**Planning application no. SDNP/13/05896/CM**  
**by Celtique Energie to drill at**  
**Fernhurst, West Sussex:**  
**Additional comments on environmental statement**  
**in the context of relevant geology and hydrogeology**

**By**  
**David K. Smythe**  
**Emeritus Professor of Geophysics, University of Glasgow**

30 June 2014

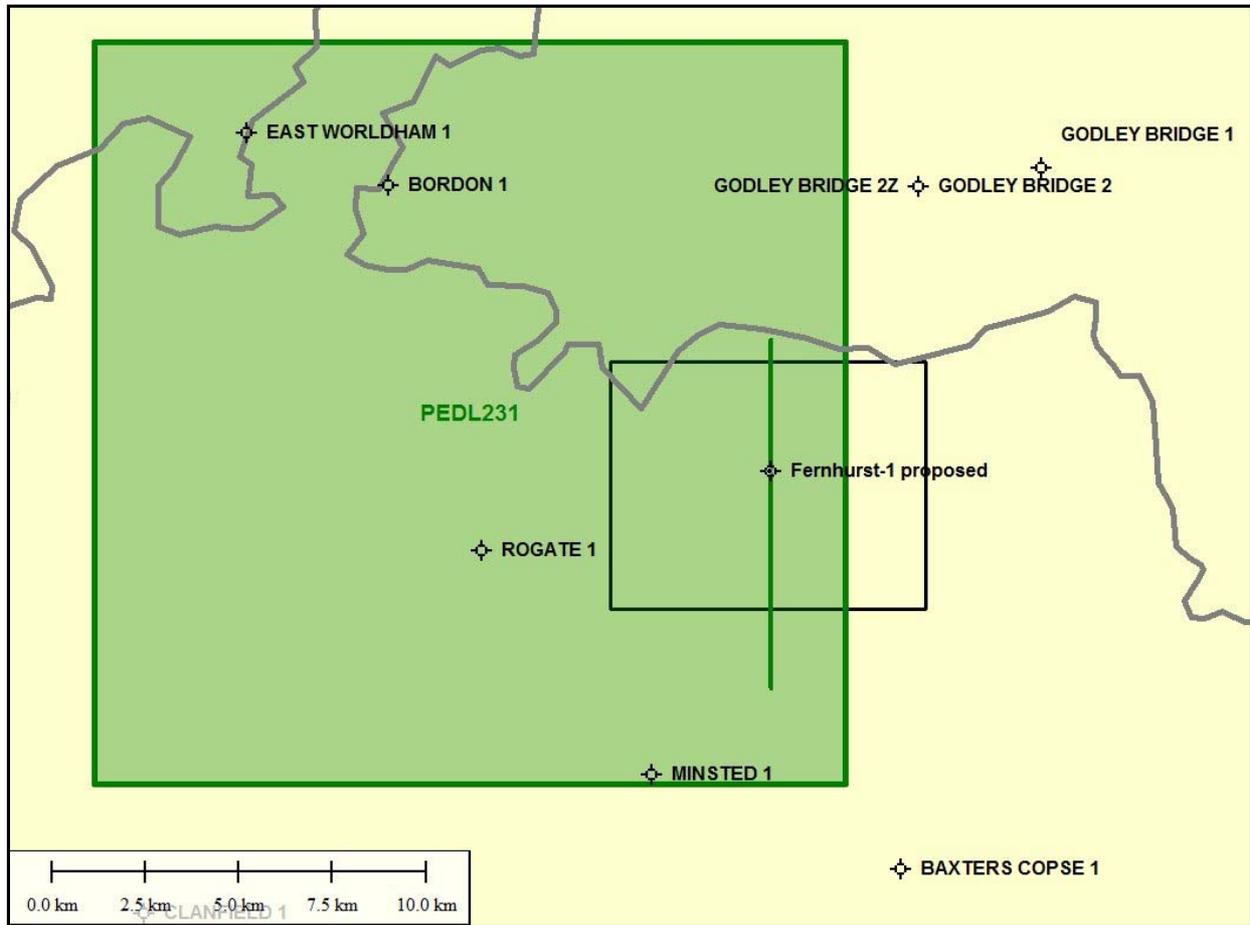
No information is provided to justify the statement that the two wells cited are "*relevant*". They do not appear on the Applicant's figure 11.2; in fact they are way off the map, as shown in Figure 2 herein. PEDL231 is shown by the green square. The smaller rectangle with the proposed well at the centre is the area covered by the Applicant's figure 11.2. Note that the "*relevant*" wells, Godley Bridge and Baxter's Copse, are a long way outside the area of figure

11.2. There are two vertical Godley Bridge wells, plus a horizontal Godley Bridge 2Z, therefore it is unclear to which of these three wells the Applicant is referring. Why are these two, and only these two, wells relevant? They lie at about 11 km distance from the proposed wellsite, whereas other existing wells are closer.

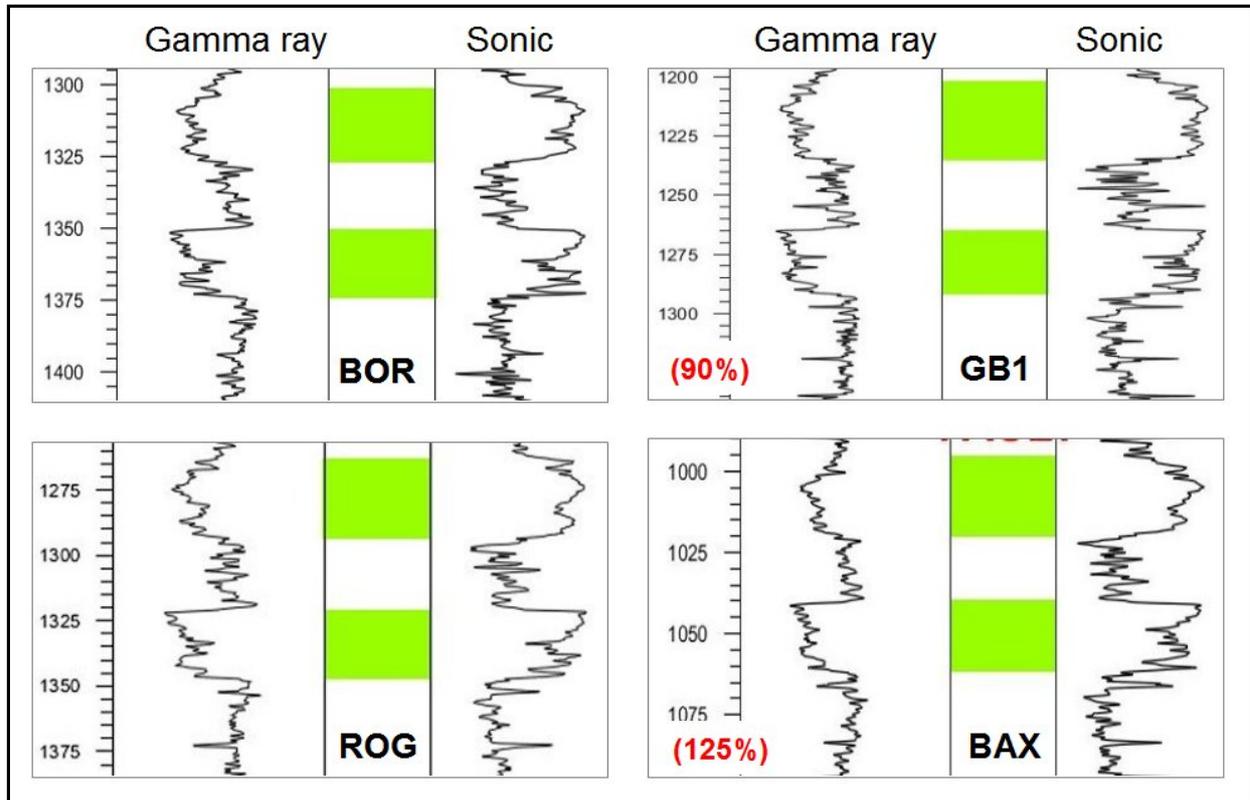
Figure 4 shows a comparison of four logs spanning the Kimmeridgian limestone sequence (the two green layers). BOR - Bordon-1; GB1 - Godley Bridge-1; ROG - Rogate-1; BAX - Baxter's Copse-1. The four wells are the nearest existing wells to the proposed Fernhurst wellsite for which the BGS has published the logs. The vertical scale of the Godley Bridge log has been reduced by 10%, while the Baxter's Copse log has been expanded by 25%, relative to the two logs on the left, to enable easy comparison. The vertical scale adjustment compensates for the fact that the Godley Bridge-1 sequence is 10% thicker, and the Baxter's Copse-1 sequence 20% thinner, respectively, than the Bordon and Rogate sequences shown on the left in Figure 4.

The Applicant has made no mention of permeability. On the question of the supposed porosity variations in the limestones in the Applicant's statement quoted above, Figure 4 demonstrates from the well logs that the porosity is essentially identical in the four wells. Figure 5 further demonstrates that this constant porosity extends north to the Coxbridge-1 well. Therefore the assertion that porosity variations have guided the site selection process is false. The porosity is effectively much the same over the whole central and eastern part of PEDL231 and beyond to the north and east.

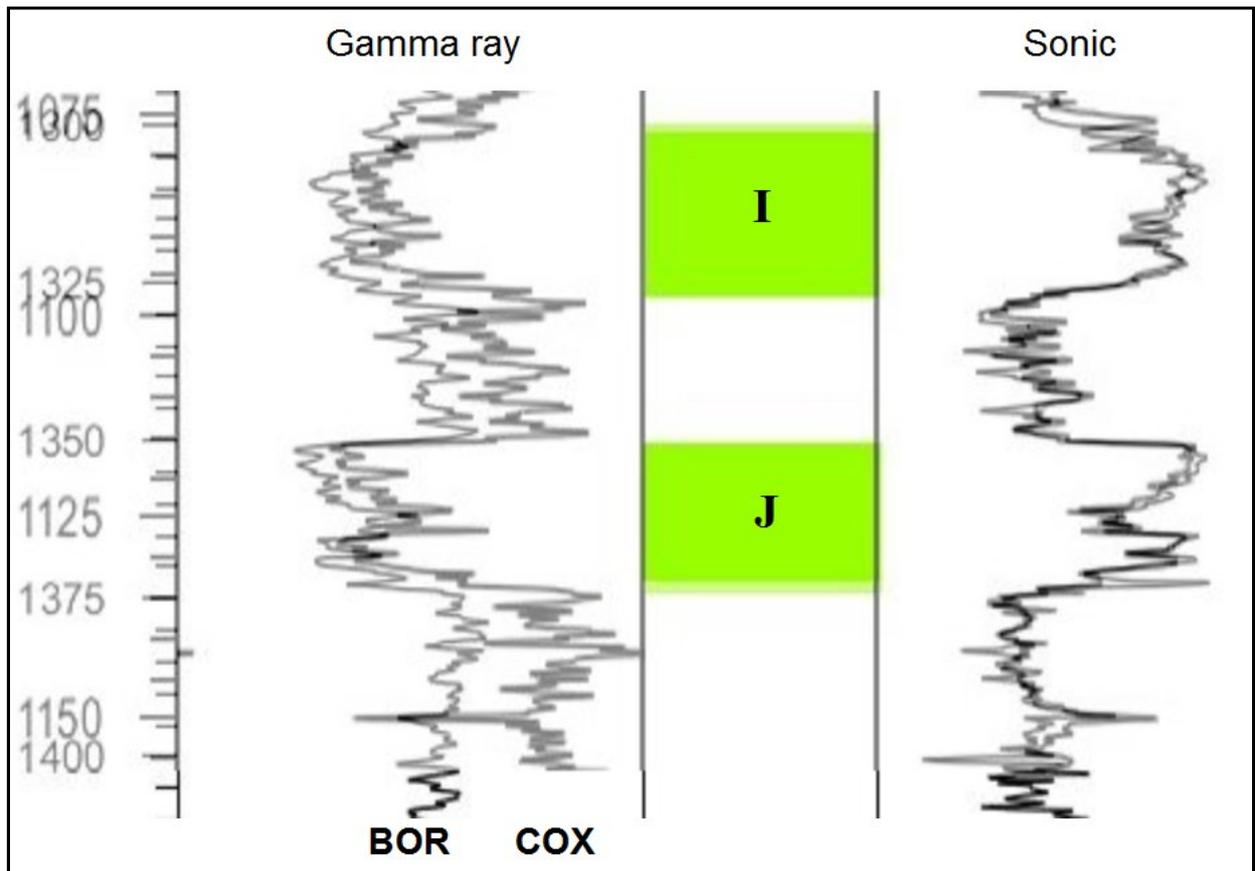
Figure 5 is an overlay of part of the well logs for Coxbridge-1 and Bordon-1 covering the two Kimmeridgian limestones I and J. The Coxbridge well is 11 km north of the Bordon well (see Fig. 3). The vertical scale of the former has been expanded by 127% so that the logs can be compared; in other words the thickness of the Coxbridge geological sequence is about 20% thinner than that at Bordon. The two wireline logs are remarkably similar; the sonic logs are essentially identical, and the gamma ray logs are closely similar, except that Coxbridge is offset about 10 API units higher (to the right). This is not significant, and may be due to instrumental or borehole factors, and not to a uniformly increased radioactive content. Below the J limestone the gamma ray reading in the shale is, however, slightly higher.

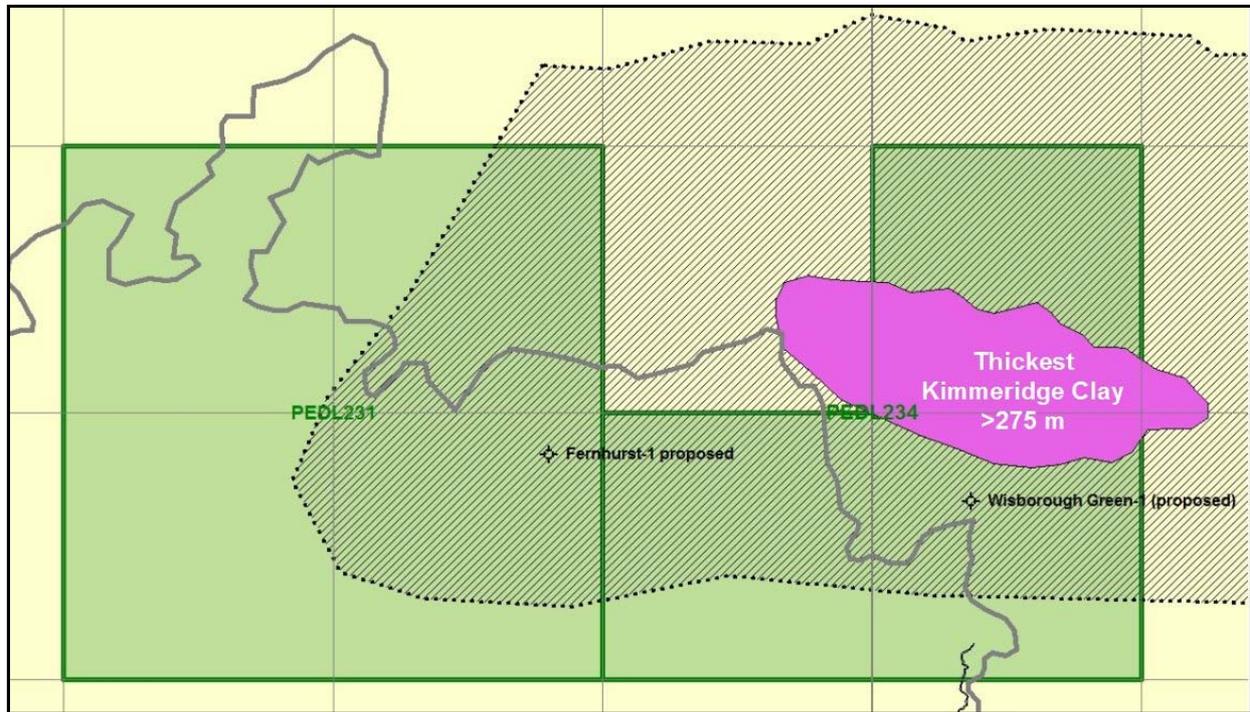
One of the most important exploration criteria for these unconventional 'plays' is the net thickness. Figure 6 shows the estimated net thickness of mature target Kimmeridge Clay from the new BGS map (Andrews 2014, appendix G, fig. 38). The contours have been traced from the map after colour conversion to 8-bit, which displays the colour spectrum of the original images in discrete bands. The Kimmeridge Clay is up to about 300 m thick. The hatched area is the outer limit of the shale, and the thickness increases smoothly towards a maximum within the lilac area. It is evident that the proposed drillsite, although within the mature Clay zone, is nowhere near the area of maximum thickness.

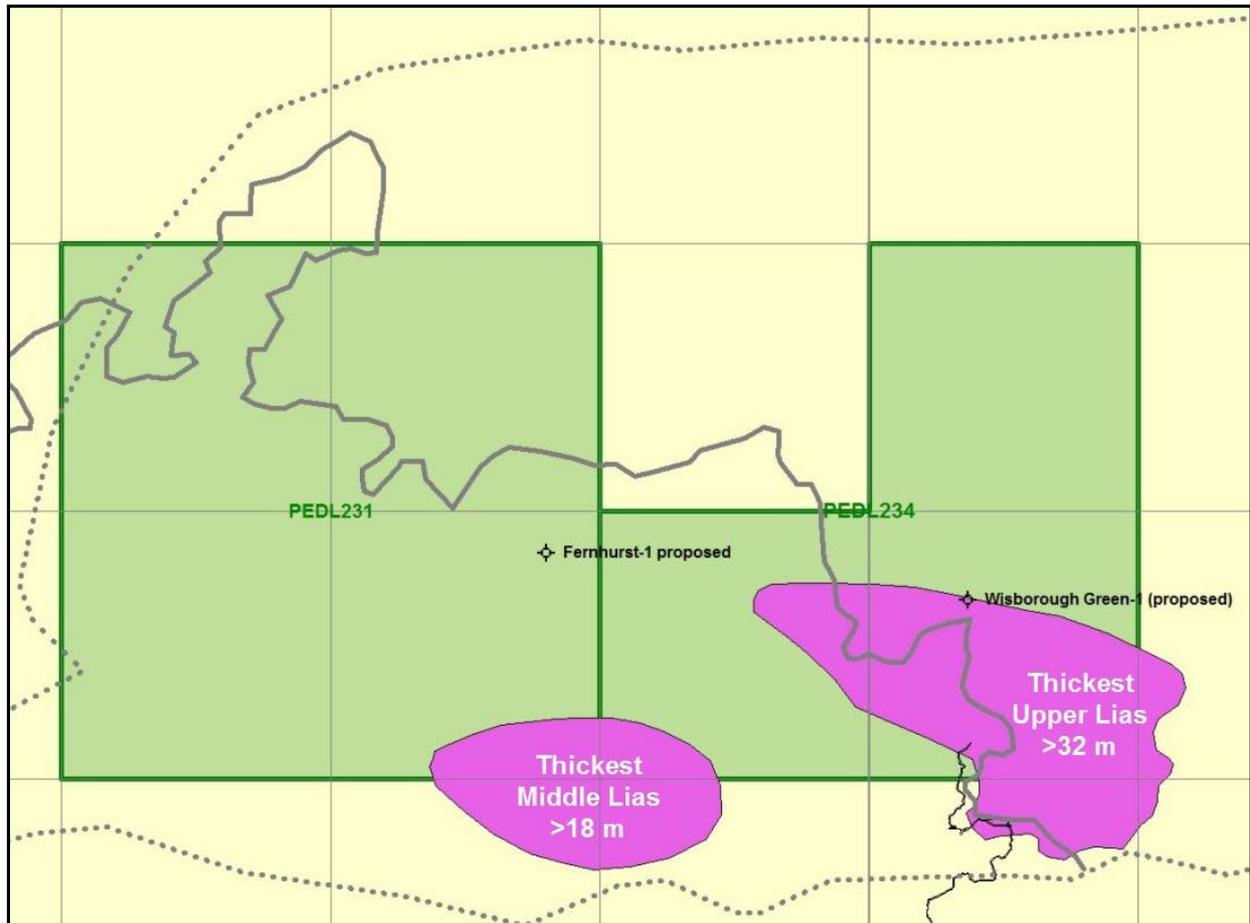
Figure 7 shows the estimated net thickness of mature target Middle and Upper Lias from BGS maps (Andrews 2014, appendix G, figs. 29, 30). Contours have been traced from the maps after colour conversion to 8-bit, which displays the colour spectrum of the original images in discrete bands. The Middle Lias area shown in lilac is up to 19 m thick; the Upper Lias up to 35 m thick. The dotted line is the outer limit of the two mature shales. The thickest areas both lie towards the southern margin. As with the Kimmeridge Clay, the areas of maximum thickness are nowhere near the proposed wellsite.

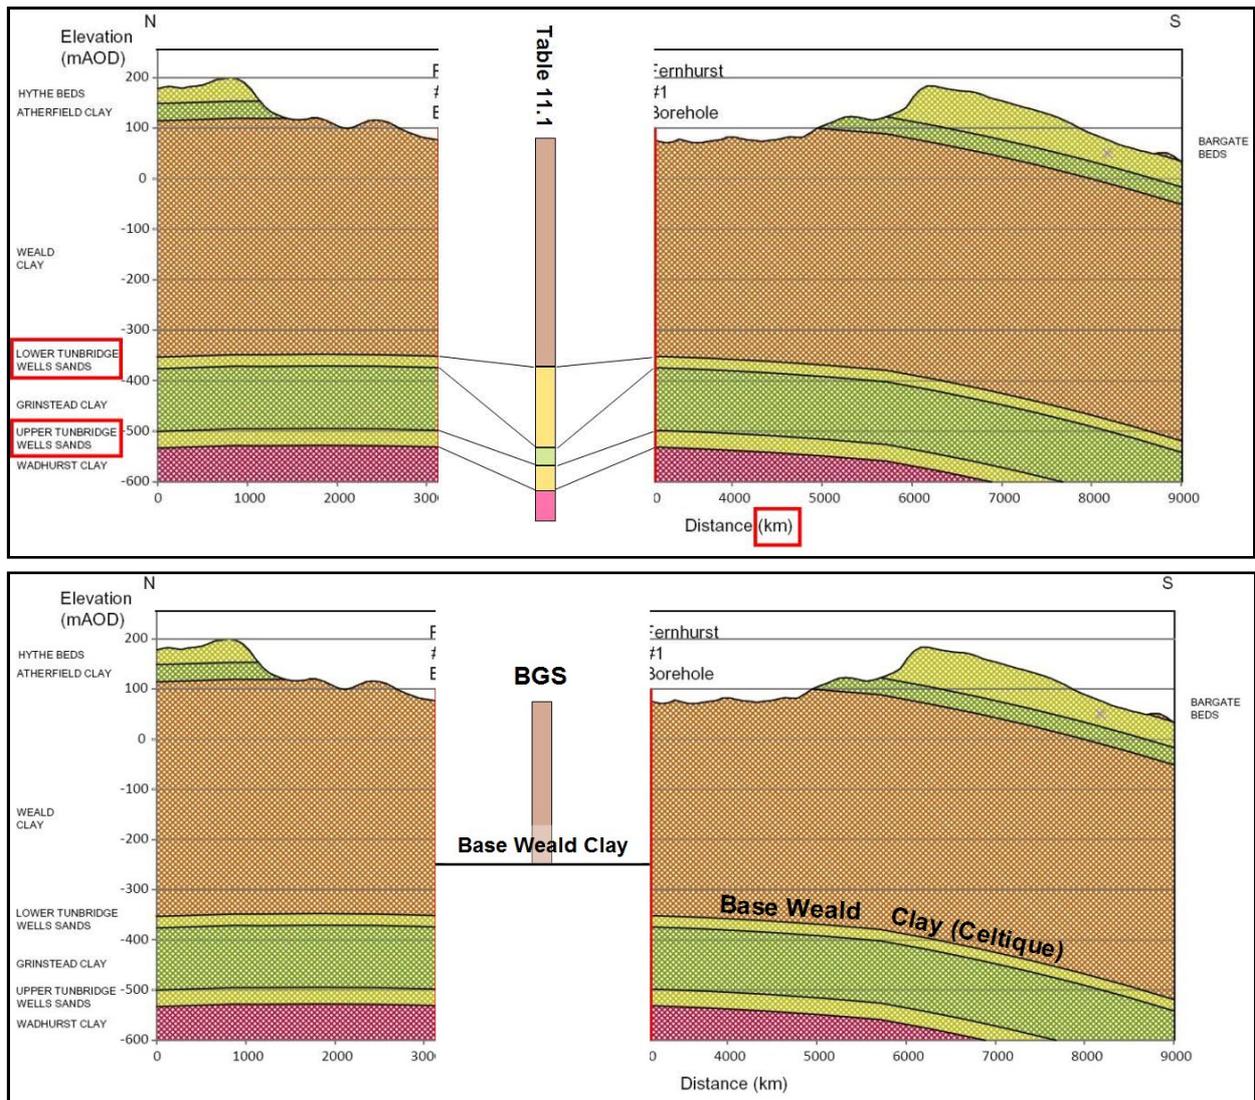
Figure 2 shows the location of a north-south cross-section through the proposed well. The cross-section is shown in the Applicant's figure 11.3, 'Indicative Geological Structure'. Figure 8 shows this cross-section split apart at the borehole location to allow insertion of a geological column. The upper diagram shows a geological column taken from Celtique table 11.1, 'Expected Geological Sequence', showing the expected depths to the various layers. These figures have not changed in the revised chapter 11. Allowance is made for the site elevation of 70 m above sea level, and the height of the drilling platform, about 7 m above site level, from which these depths are measured. Figure 8 shows that the depths to the Base of the Weald Clay are reasonably consistent, to within about 10 m, but the deeper layers are grossly in error. Either the table is wrong or the cross-section is wrong; the top of the Wadhurst Clay (red cross-hatching) is 80 m deeper according to the table, as compared to the cross-section; the Grinstead Clay (green cross-hatching) is 34 m thick according to the table, but about 125 m thick on the cross-section.

The Upper and Lower Tunbridge Wells Sand layers, between which the Grinstead Clay is sandwiched, are labelled the wrong way round (red boxes). The horizontal scale shows units which are clearly in metres and not kilometres.

The lower part of Figure 8 shows the Weald Clay as a column, taken from the BGS contour map which forms part of the Haslemere solid geology Sheet 301 (British Geological Survey 1981). The -250 m contour (negative, because depths are measured upwards from sea level) of the base of the Weald Clay runs through the proposed well location. This depth, marked by the horizontal line at the base of the column in Figure 6, is 100 m higher than the -350 m depth shown by the Applicant.

Fig. 9. Celtique cross-section (location shown in Figure 2 above) through proposed wellsite (solid colours) with overlain lines of:

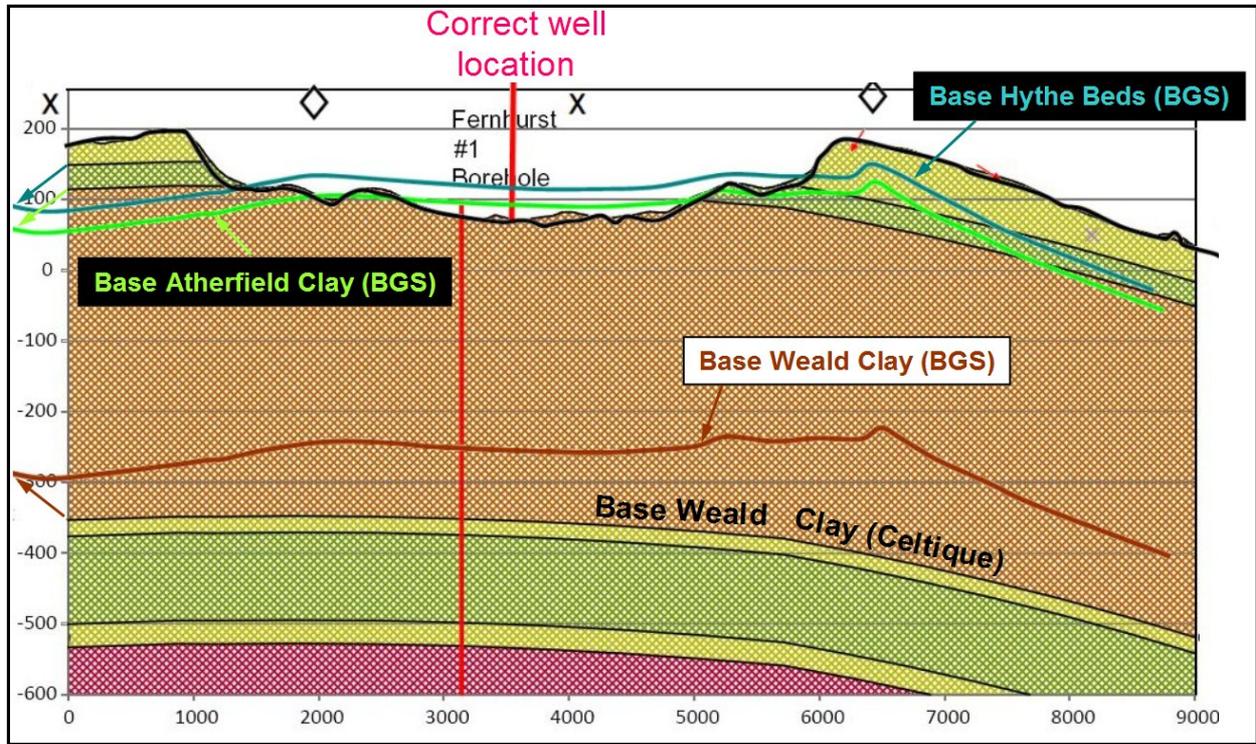
Not only are the depths and thicknesses shown on the Applicant's figure 11.3, 'Indicative Geological Structure' in serious error, but the main features of the structure are misleading as

well. I have reconstructed the cross-section using the BGS 1:50,000 geology sheet and the OS digital terrain model. This is shown in Figure 9 as overlain lines on the Celtique cross-section.

The two versions of the topography match closely, confirming that there is no lateral positioning error to north or south. Axes of synclines and anticlines (down-folds and upfolds of the layers) are indicated by an X and by a diamond, respectively. The blue and green lines shown above ground level indicate the 'ghost' structure before the rocks in the central valley between the two scarps were eroded away. The coloured arrows at the left-hand side indicate the correspondence between the Celtique horizons (boundaries between layers) and the re-drawn lines.

There are positioning errors in the outcrops of the rocks below the northern scarp, in that the Atherfield Clay crops out several hundred metres south of the location shown by Celtique. The Celtique structure of a simple anticline has been oversimplified. If account is taken of the various structural axes shown by the BGS then the structure is flatter in the central valley area. The culmination of the structure, or high point, is not in the area of the proposed well, but in fact lies about 3 kilometres to the south. The most serious error is in the overestimate of the Weald Clay thickness by 100 to 150 m, or 30-50%.

Lastly, the location of the proposed well itself is mispositioned on the cross-section, being shown as 400 m north of its actual location.

- Correct topography (black)
- Correct Base Hythe Beds (blue)
- Correct Base Atherfield Clay (green)
- Correct Base Weald Clay (brown)

taken from the BGS 1:50,000 sheet and OS digital terrain model. Arrows at left indicate link of Celtique layer to overlain corrected layer. Axes of synclines and anticlines are indicated by an X and by a diamond, respectively. The blue and green lines shown above ground level indicate the 'ghost' structure that existed before the rocks in the central valley between the two scarps were eroded. The correct location of the proposed well is 400 m south of the location marked by the Applicant.
